Request for review

Please find below the response to the request for review formulated for the CDM project with the registration number 0099. In case you have any further inquiries please let us know as we kindly assist you.

Response to the CDM Executive Board

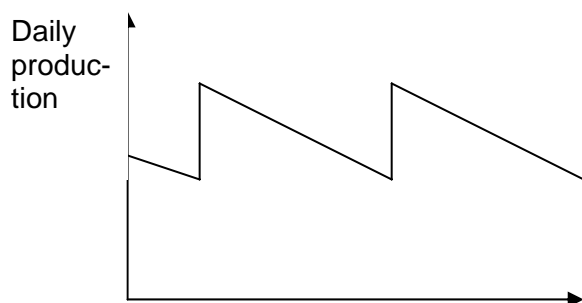
Issue 1:

During the monitoring period of 24 days, the average adipic acid production was 434 TPD, exceeding the maximum production of 415 TPD as set in the PDD. Further clarification is required.

According to monitoring methodology AM0021, installed capacity is measured in tonnes of adipic acid per year. The monitoring methodology specifies that the nameplate capacity for adipic acid production of 2004 as per manufacturer's specifications is to be provided once at the time of submission of PDD. Nowhere in the methodology, daily production capacity is mentioned. The PDD in Section A provides a yearly adipic acid nameplate capacity of 151,475 tonnes.

TÜV SÜD's assessment team has verified in this Periodic verification #9 report No. 953337-PV09 that the cumulative adipic acid production in the year from September 01, 2006 (start date of first monitoring period and of the Crediting Period) to August 31, 2007 (end date of current monitoring period) is below the yearly maximum production (151,475 tonnes) defined in the PDD. For confidentiality reasons due to high competition in adipic acid production, cumulative production of adipic acid in the year from Sep. 1 2006 to August 31, 2007 is not listed in the public monitoring report but in the Workbook ER ONSAN sheet "AM" submitted to UNFCCC. Up to the end date of the monitoring period on August 31, 2007, cumulative year 2007 production of adipic acid had also not reached the maximum value of 151,475 tonnes.

The daily production rate of adipic acid varies considerably over time due to characteristics of adipic acid production, which is a complex process of 8 main steps. One key step of the process is the Crystallization. Performed by 4 crystallizers of different sizes (D21100, D21200, D21400, D21600). The daily production rate is linked to the state of the surfaces of the plate coils inside the crystallizers. The corrosion by the acid of these plates coils leads to a poor exchange cooling efficiency of the plate coils, so to longer time cycles and then lower daily production. It is common practice to clean (mechanical polishing, chemical cleanings) and change the plate coils (as repetitive cleanings consume the plate coils and reduce the metal thickness). Since 2000, on the 4 crystallizers this was performed 37 times. The plates coils of crystallizers D21400, D21600 were changed during plant stoppage end of June with the same material(304L) which has improved the reliability of these sections. We will loose again the capacity in the future when the corrosion affects the surface of the plate coils; over time, the daily production will decrease again until the next cleaning is done (see graph below).

We herewith confirm the statements given by the project participants and emphasize that limiting daily production at the indication given by the PDD is considered as subjective interpretation of the reviewer and not reflected by the methodology. The compliance with the annual production threshold has been verified.
